Access Compliance Report

Public Rights-of-Way

(Curb Ramps)

Intersection ID: 11956	Main Street: E_9TH_ST	Cross Street: N_COLLEGE_ST	Location: E
ADA ID: FE8CC882F575	Ramp Type: PerpDiag	Initial Pass/Fail: Fail	Overall Compliance: No
Severity Score: 8.75			
Codes/Mitigation Info/Possible Solution		Field Measurements/Component Compliance

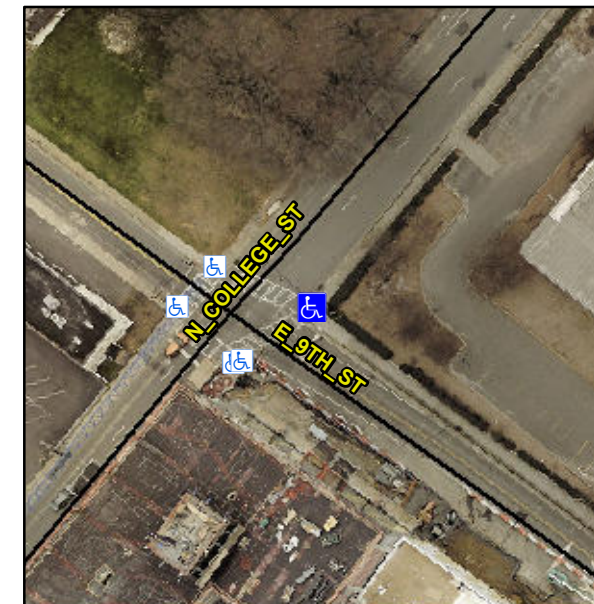
Not Found, R304.5.1

Compliance	Description	Data	Compliance	Description	Data
N/A	Ramp Length (in)	40.0	Yes	Ramp Slope (%)	7.6
No	Ramp Width (in)	47.5	Yes	Ramp XSlope (%)	1.4
N/A	Flare Type LT	N/A	N/A	Flare Type RT	N/A
N/A	Flare Slope LT (%)	N/A	N/A	Flare Slope RT (%)	N/A
N/A	Flare Traversable LT?	N/A	N/A	Flare Traversable RT?	N/A
N/A	Landing Length (in)	N/A	N/A	DWS Provided?	N/A
N/A	Landing Width (in)	N/A	N/A	DWS Contrast?	N/A
N/A	Landing Slope (%)	N/A	N/A	DWS Length (in)	N/A
N/A	Landing X Slope (%)	N/A	N/A	DWS Full Width?	N/A
N/A	Landing Curb? (Y/N)	N/A	N/A	DWS Offset (in)	N/A
N/A	Shared Landing?	N/A			
N/A	Gutter Ponding?	N/A	N/A	Gutter Slope (%)	N/A
N/A	Gutter Lip Ht (in)	1.0	N/A	Gutter X Slope (%)	N/A
N/A	Painted X Walk1?	Yes	N/A	Painted X Walk2?	Yes
	X Walk 1 Direction	To NW		X Walk 2 Direction	To SW
N/A	X Walk 1 Width (in)	95.0	N/A	X Walk 2 Width (in)	95.0
	X Walk 1 Slope (%)	6.7		X Walk 2 Slope (%)	3.4
	X Walk 1 X Slope (%)	0.7		X Walk 2 X Slope (%)	7.8

Remove & Replace Curb Ramp With Two New Directional Ramps or Equivalent.
